7C Defense Against Common-Mode Failure in Safety-Related, Software-Based I&C Systems

The information in this appendix of the reference ABWR DCD, including all subsections and figures, is incorporated by reference with the following departures.

STD DEP T1 3.4-1 (Figure 7C-1)

Figure 7C-1 Implementation of Additional Diversity in SSLC to Mitigate Effects of Common-Mode Failures

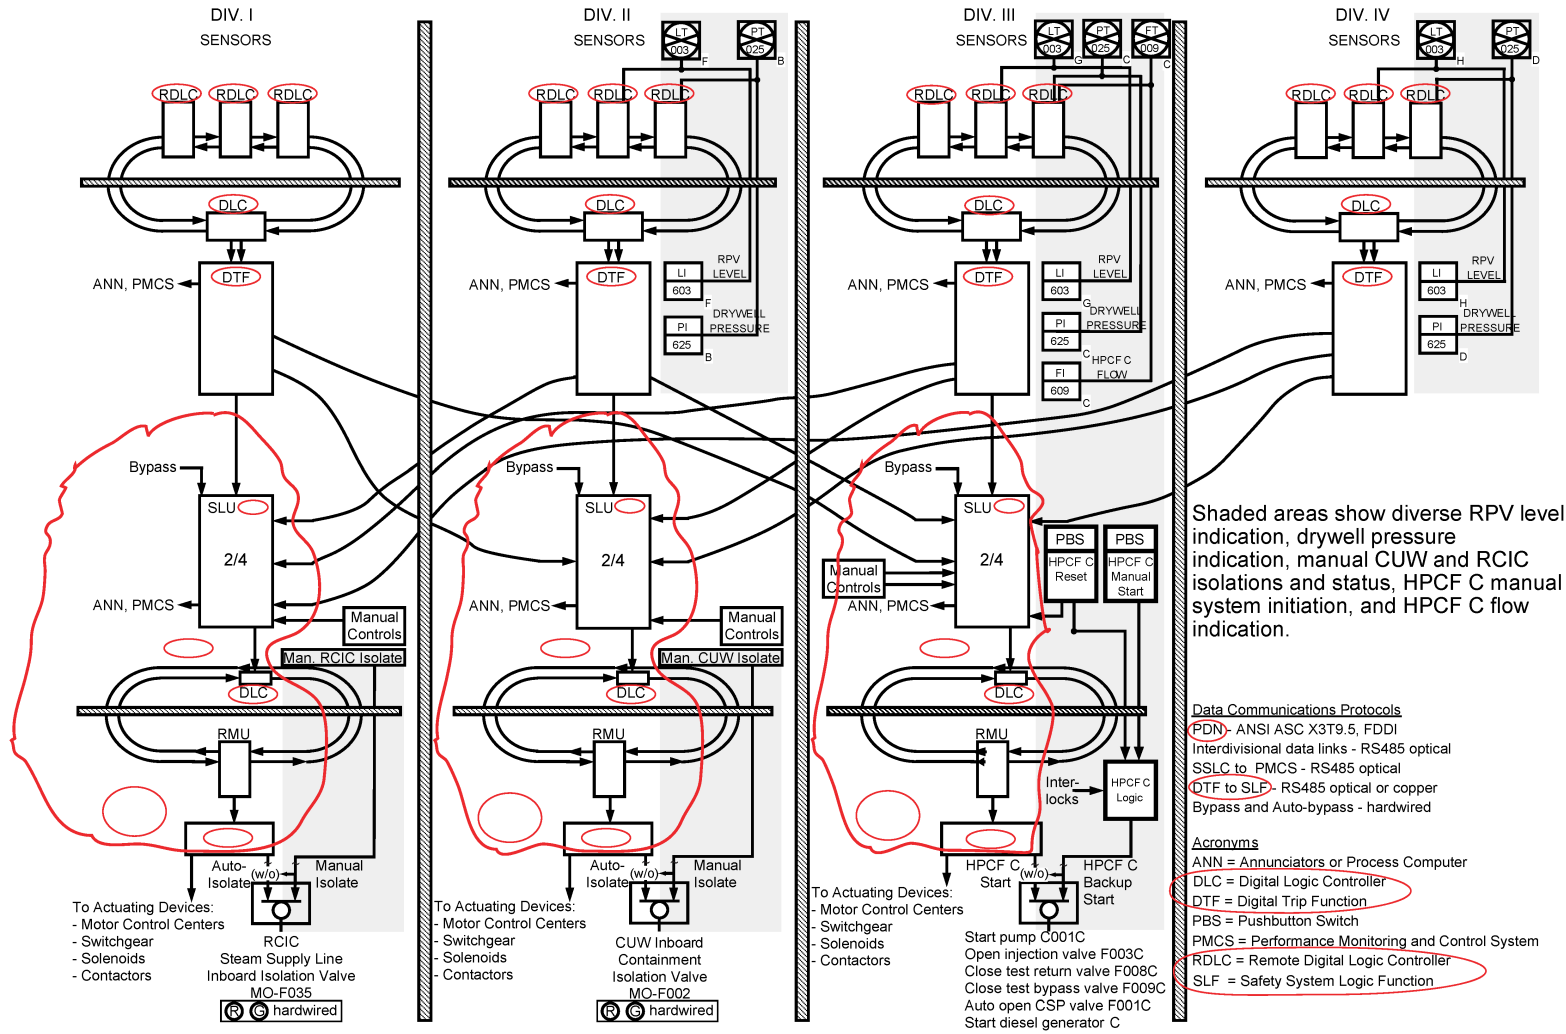
STD DEP T1 3.4-1 (Figure 7C-1)

- (2) Defense-in-depth configuration:
 - (a) Fail-safe RPS and fail-as-is ESF in separate processing channels
 - (b) Control systems ~~supporting diverse injection~~ are independent of RPS and ESF in separate triplicated processing network using diverse hardware and software from the ~~Essential Multiplexing System~~ Essential Communication Function (ECF) network

Shaded areas show diverse RPV level indication, drywell pressure indication, manual CUV and RCIC isolations and status, HPCF C manual system initiation, and HPCF C flow indication.
